PRODUCT SUPPORT BULLETIN BULLETIN NO. 275

MACHINE: Super B Spiker
Super B-2 Spiker
Hydra-Hammer Models A, B, B-2
Model 44 Spiker

SUBJECT: Jaw Mounting Use

21358981 with steel anvil bushing

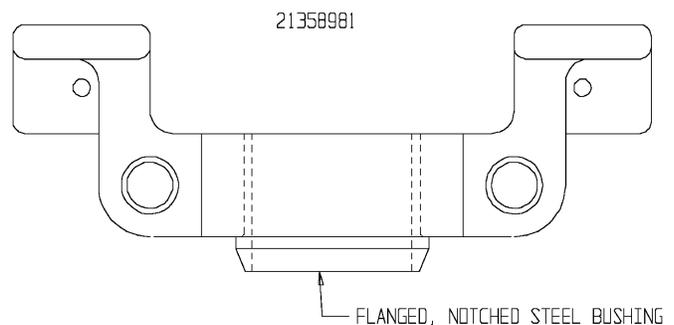
Used on Super B Spikers and Model 44 Spikers with the original extension style jaw springs, and Hydra-Hammers with extension style jaw springs and one-piece anvils only. This jaw mounting uses a steel flanged anvil bushing, p/n 22123300.

21358982 with bronze anvil bushing

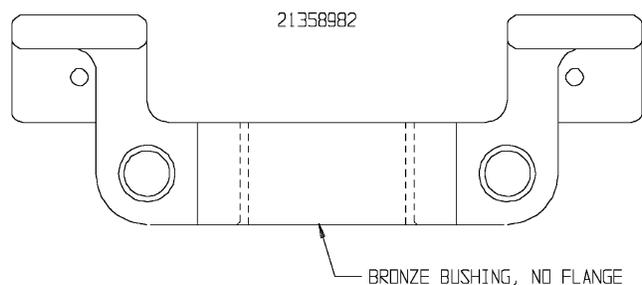
Used on Hydra-Hammers with the original style extension jaw springs and one or two-piece anvils only. This jaw mounting uses a bronze anvil bushing with no flange, p/n 22123301.

21358983 with bronze anvil bushing

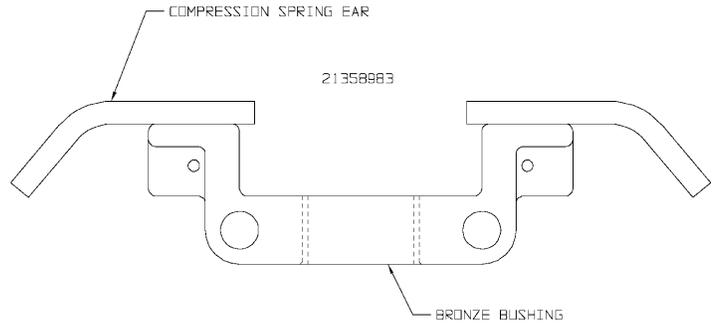
Used on Hydra-Hammers with compression style jaw springs and one or two-piece anvils only. This jaw mounting uses a bronze anvil bushing, p/n 22123301, and has compression spring ears.
